DESIGN/DEVELOPMENT REVIEW COMMISSION
DESIGN REVIEW DISTRICT
EVALUATION SHEET
Consent Agenda Case # 1

ADDRESS: 1409 Devine Street

APPLICANT: Doug Quackenbush, architect

NATURE OF REQUEST: Request for Certificates of Design Approval for new construction of the new USC student health center.

1 SOUTH ELEVATION
A-201 SCALE: 1/8" = 1'-0"

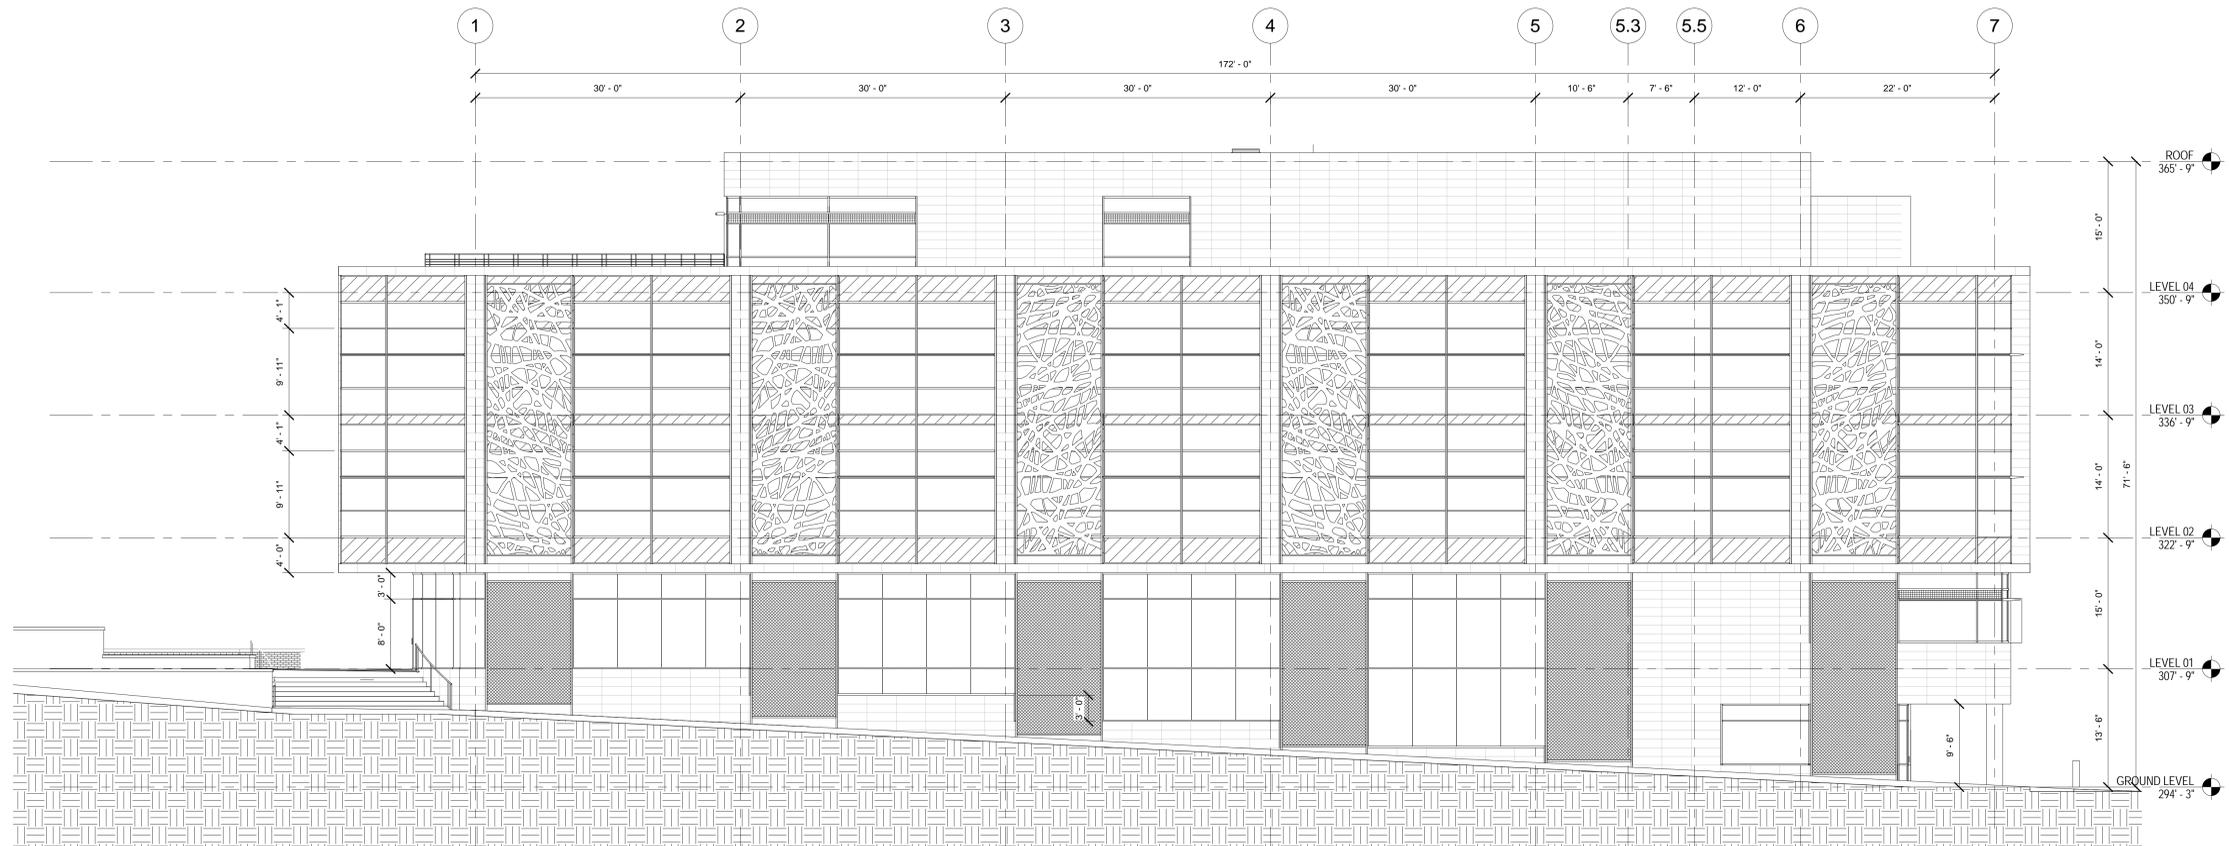
The South and West façades are well articulated both vertically and horizontally. The strong horizontal design is emphasized with extruded mullions, alternating bands of glass and fritted glass, and a horizontal ledge between the first and second level, which parallels the roof overhang. This helps create a sense of scale along the western elevation.

At the first level on the western elevation, green screens occur at regular intervals in front of the curtain wall to establish vertical articulation and also provide an interesting series of

planted screen walls. These align with the upper story metal screen panels, continuing the pattern to the roofline.

There is a roof-mounted exhaust fan shown on the west elevation. The architect verified that it will be “in the geometric center of the building, not visible from the ground within 1100’ of the building.” They are still working on the placement, and may actually eliminate it from the high roof area if possible.
